ROLLING BRANCH ESTATES SUBDIVISION, 1ST AND 2ND ADDITION

APPLICATION NUMBER 14 DATE July 1, 2004

REQUEST Subdivision

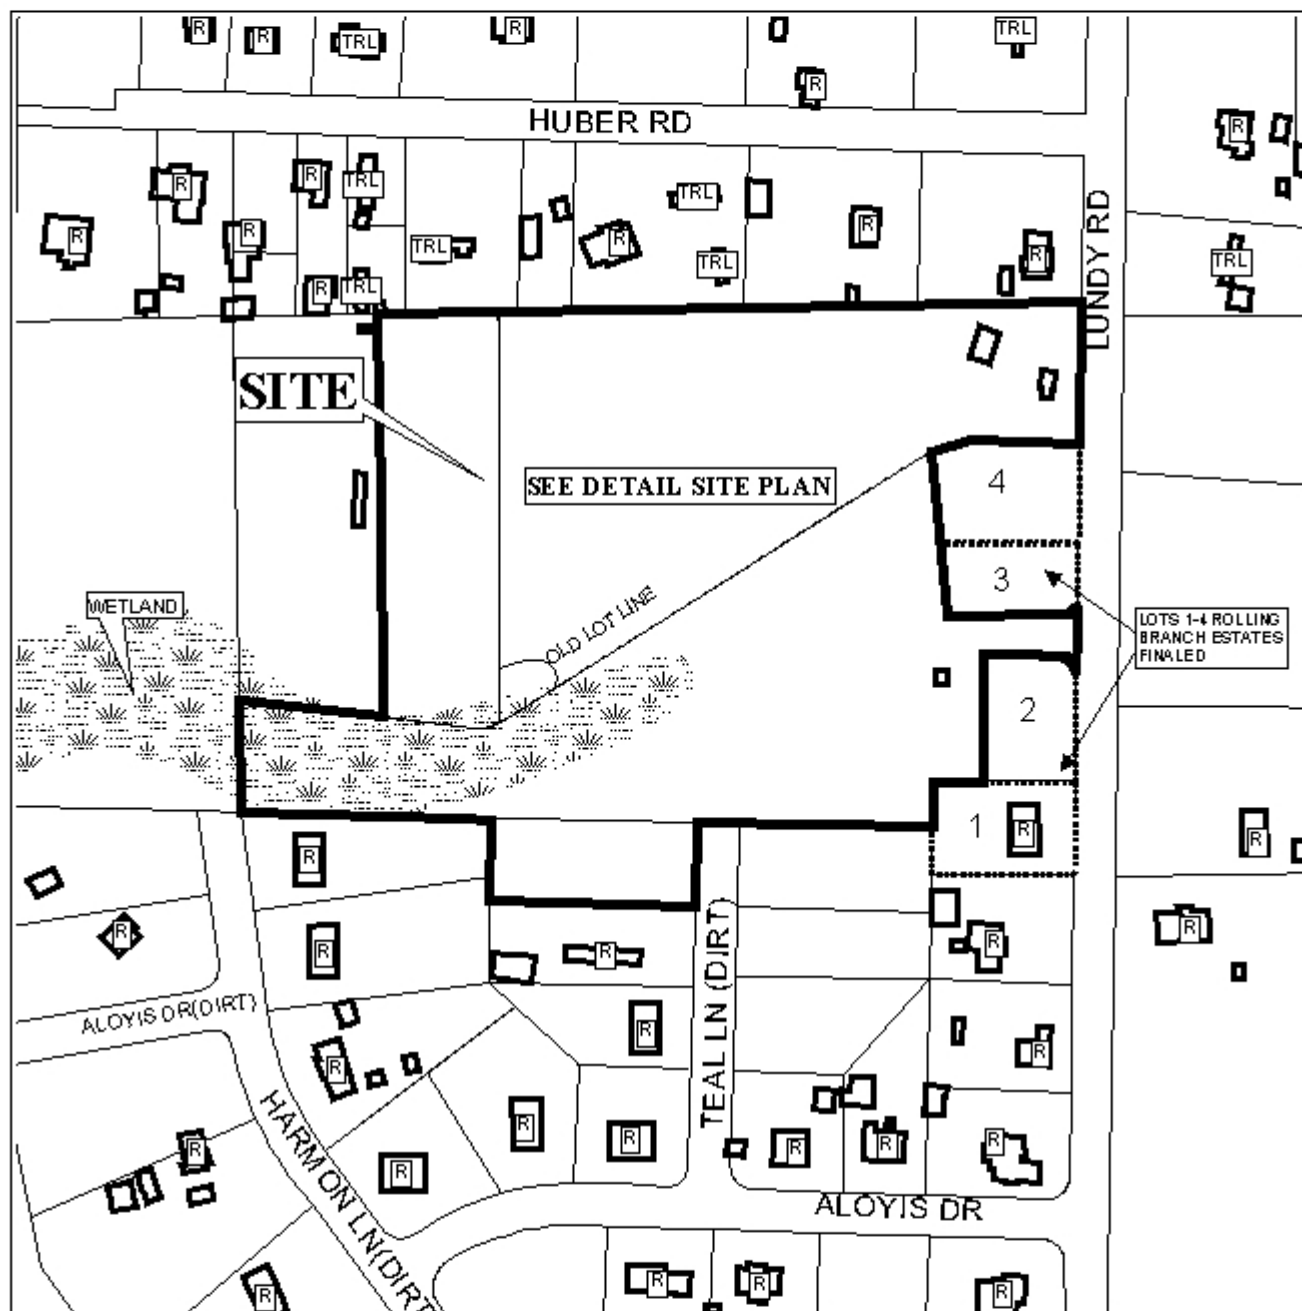
As illustrated on the Vicinity Map, the site contains wetlands, thus this area could be considered environmentally sensitive; therefore, the developer must obtain any necessary federal, state, and local environmental approvals.

DETAIL SITE PLAN

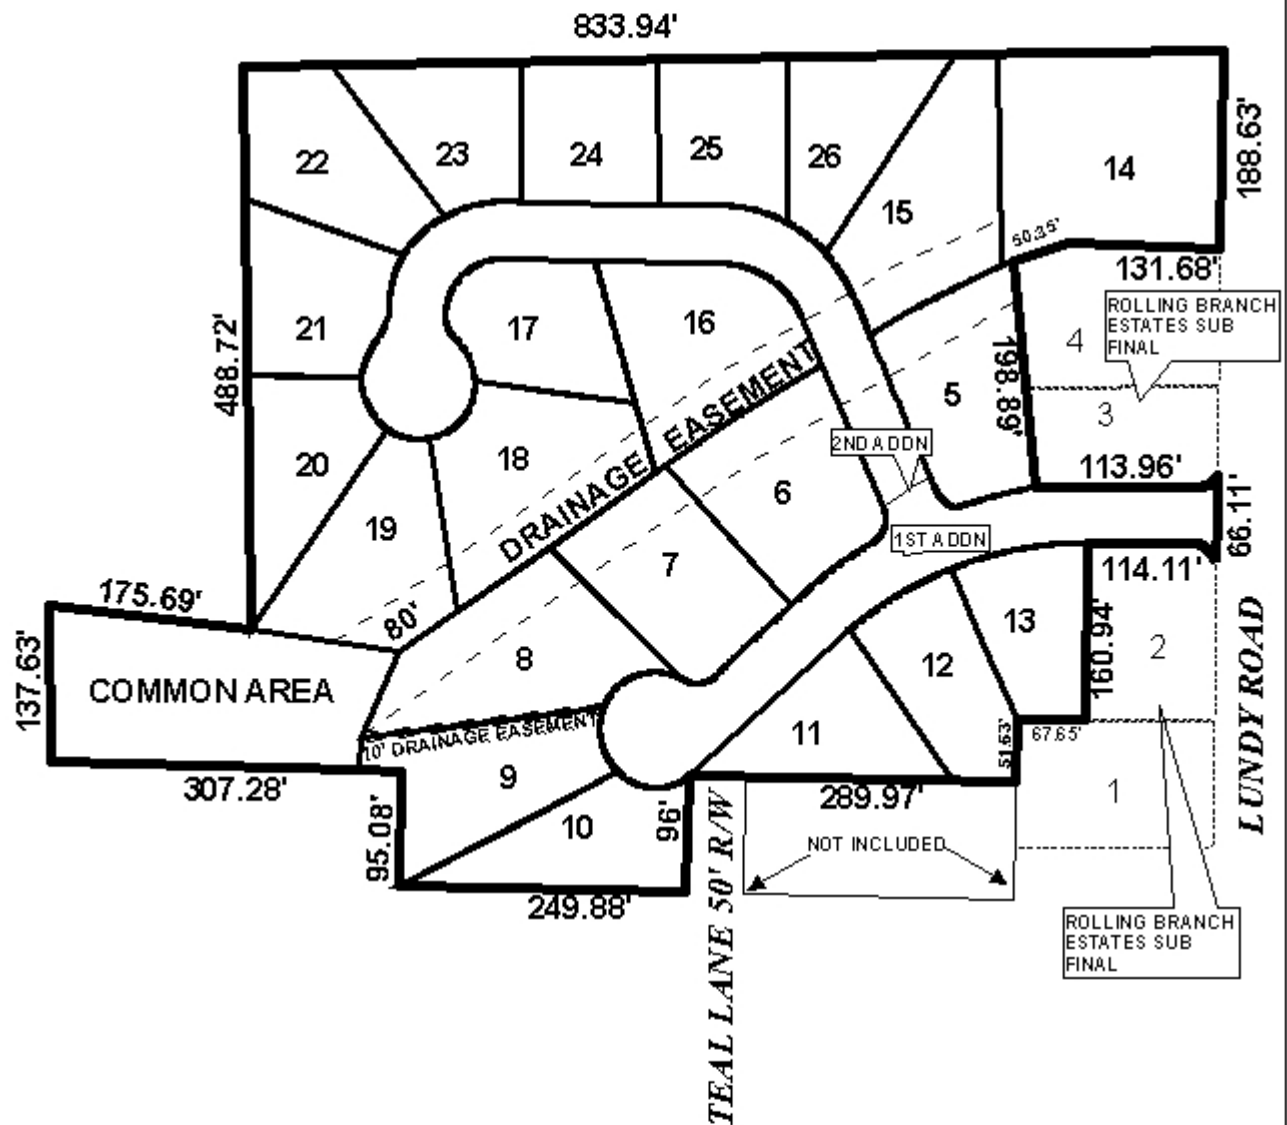
As proposed, Lots 10 and 11 would have frontage along the new street and Teal Lane. Access should be denied to Teal Lane as it is an unimproved road (dirt); therefore, the placement of note on the final plat stating that Lots 10 and 11 are denied access to Teal Lane should be required.

As illustrated on the site plan, there is a piece of property to the west that is landlocked and the staff has received a letter from the property owner stating that he does not want to participate in the subdivision. This landlocked parcel is access via a dirt driveway from Huber Road and the parties now involved did not create this problem. It should be noted that the no permits would be issued to the landlocked piece of property until a subdivision application is submitted and approved.

As shown on the site plan, there is an area at the southwest corner of the subdivision, adjacent to Lots 8, 9 and 19, that is labeled as common area; therefore, a note should be placed on the final plat stating that the maintenance thereof is the responsibility of the property owners.

The 25-foot minimum building setback line is not shown but would be required on the final plat.

The plat meets the minimum requirements of the Subdivision Regulations and is recommended for Tentative Approval subject to the following conditions: 1) the placement of note on the final plat stating that Lots 10 and 11 are denied access to Teal Lane; 2) the area in the southwest corner of the subdivision, to the rear of Lots 8, 9 and 19 to be labeled as common area and a note placed on the final plat stating that the maintenance thereof is the responsibility of the property owners; 3) the placement of a note on the final plat stating any lots which are developed commercially, and adjoin residentially developed property, must provide a buffer, in compliance with Section V.A.7. of the Subdivision Regulations; and 4) the placement of the 25-foot minimum building setback line on the final plat.
